TN04 – Further Response to WBC Highways comments

Site: 810 Winnersh Triangle Business Park, Winnersh, Wokingham
RG41 5UX
Prepared by: PdeJ
Date: 15th December 2025

- 1.1 This Highways Technical Note has been prepared on behalf of Winnersh Midco S.A.R.L. to respond to comments raised by Wokingham Borough Council Highways dated 1st December 2025, in relation to development proposals for Building 810, Winnersh Business Park, Eskdale Road, Wokingham (herein after referred to as 'the site').
- 1.2 The topics raised by WBC Highways in their latest response are summarised as follows:
- ▶ Trip generation rates;
 - ▶ Parking provision.
- 1.3 The WBC Highways comments are in **Appendix A** for reference.

WBC comments – December 2025

Office Trip Rates, Trip Generation and Parking Accumulation calculation

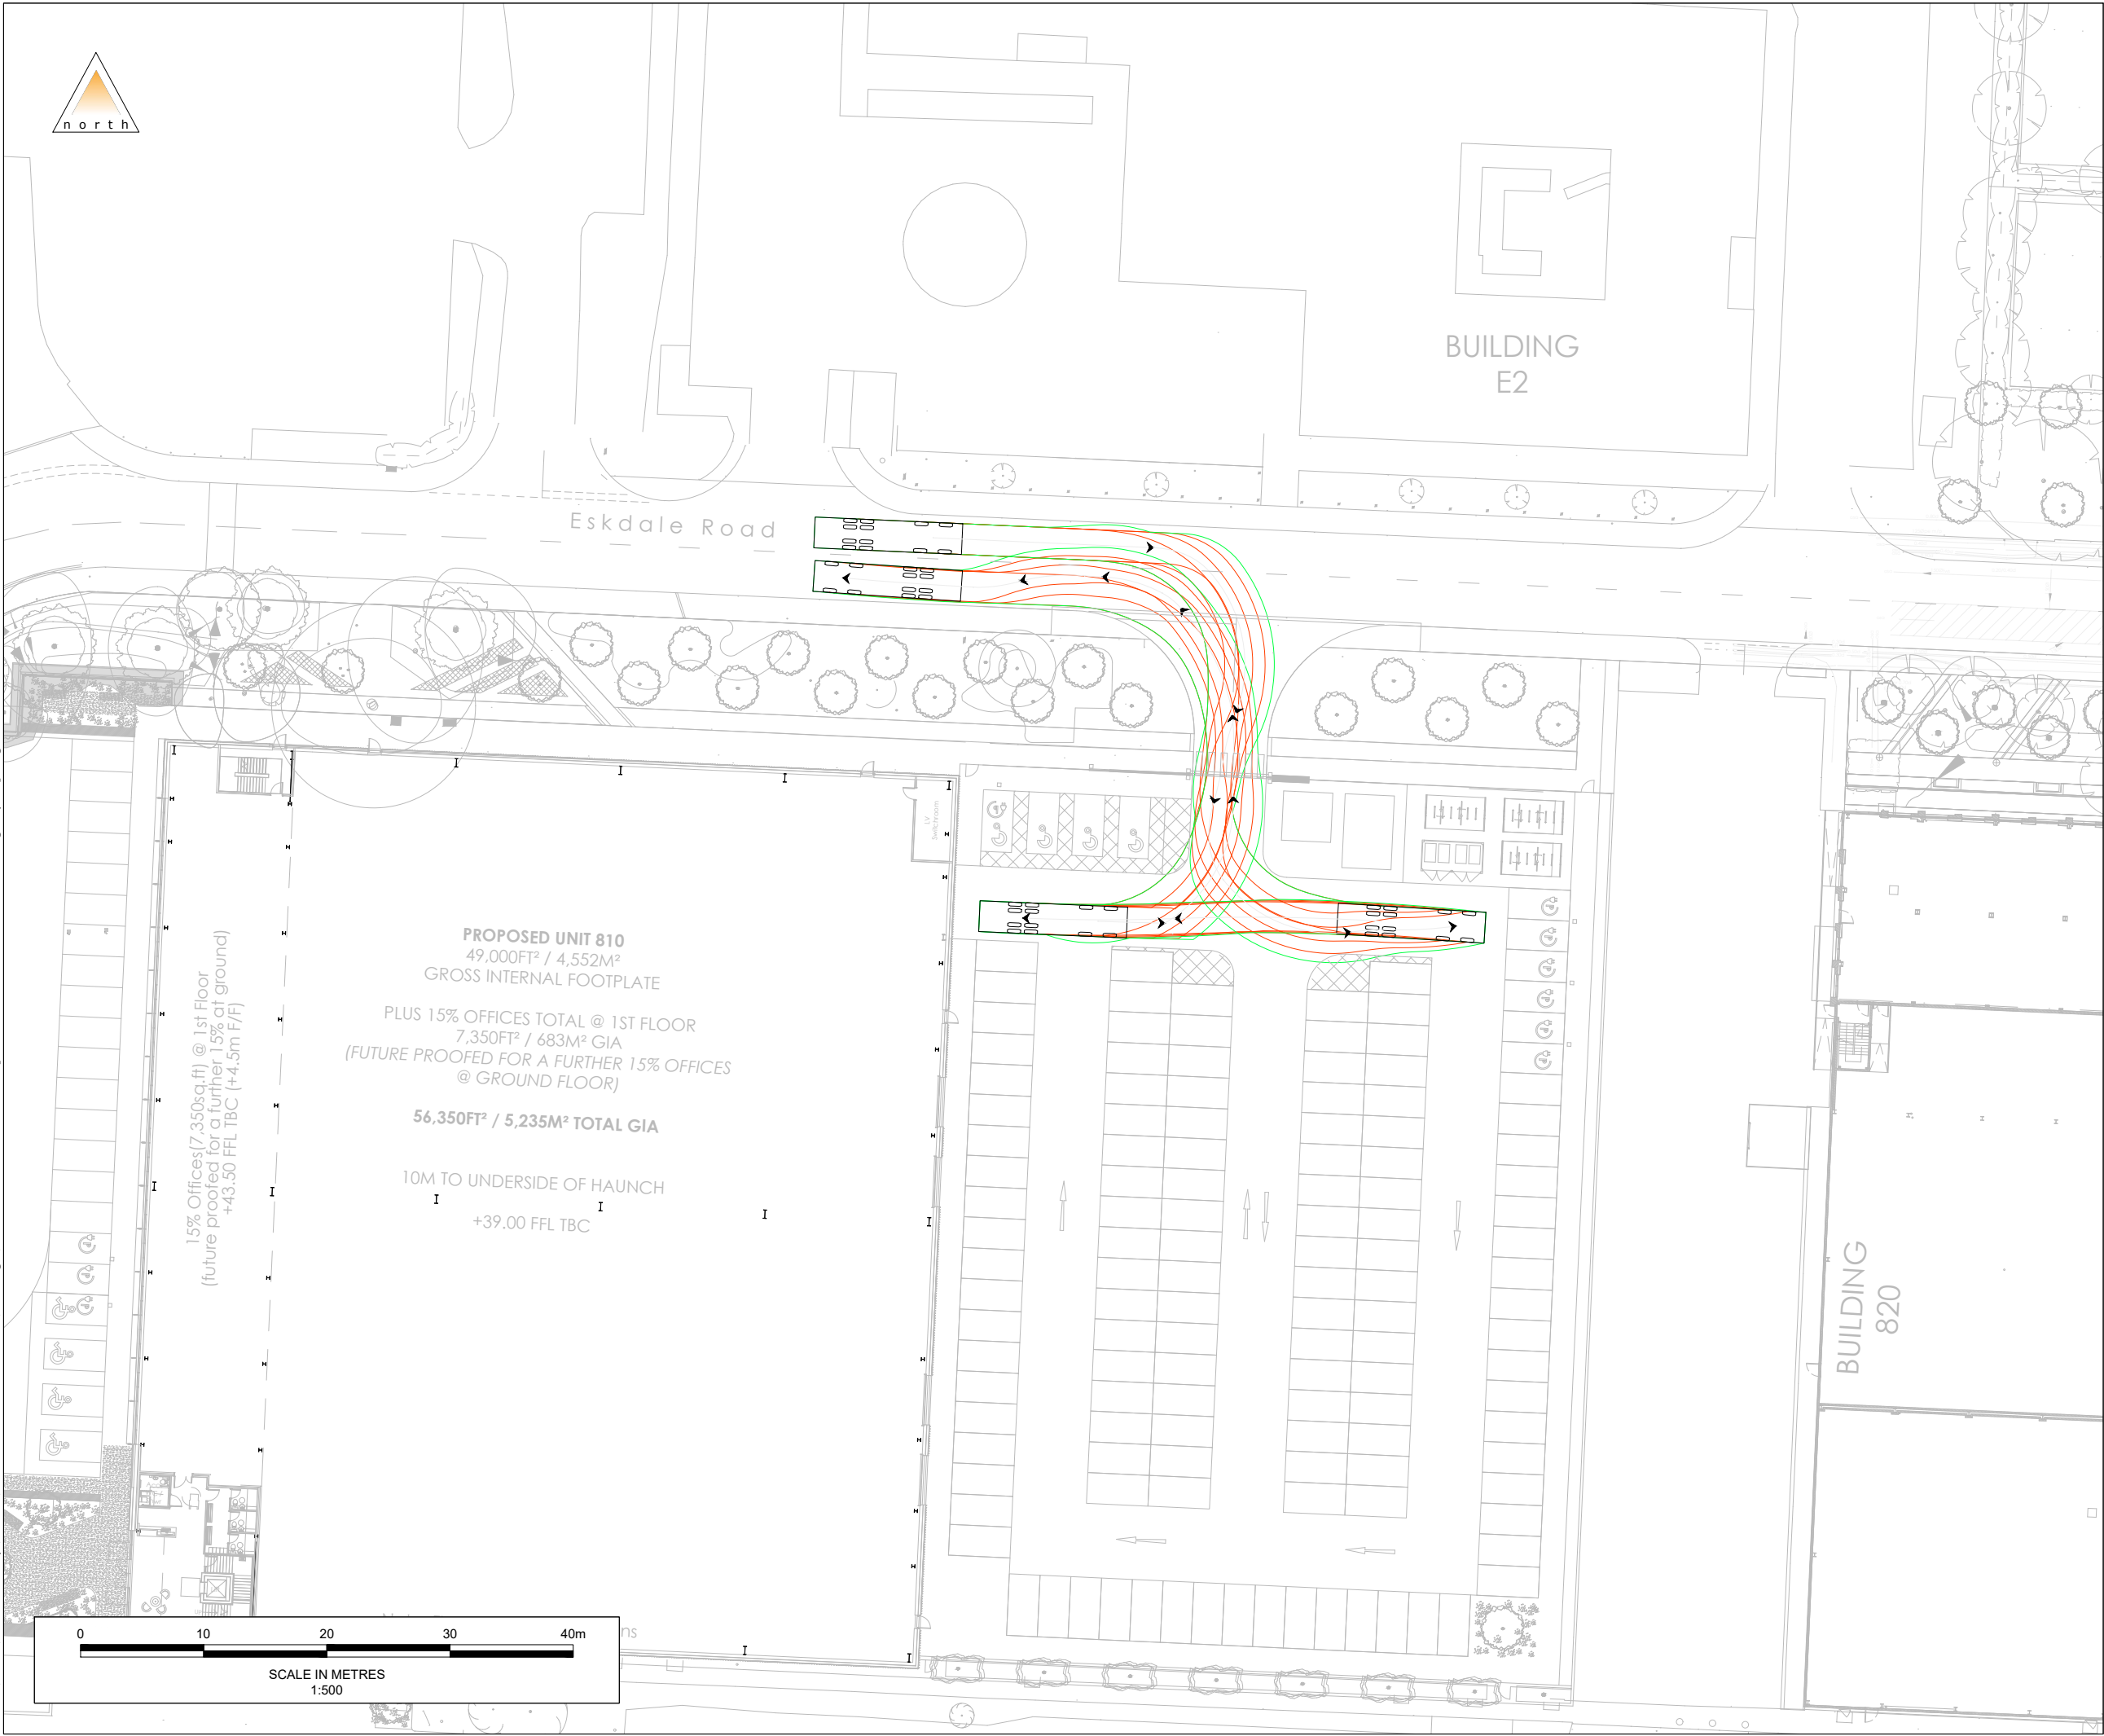
- 3.4 In the event the site accommodates a full B1 use, the proposed 167 car parking provision will be more than enough to accommodate the office car parking demand. A car parking accumulation exercise has been prepared based on TRICS trip rates and this is presented in **Appendix C**. The maximum car parking demand, based on TRICS, will be 134 vehicles should the building be occupied by 100% office space, this is well below the 165 spaces which can be accommodated within a reconfigured car park and will leave at least 21 spare spaces.
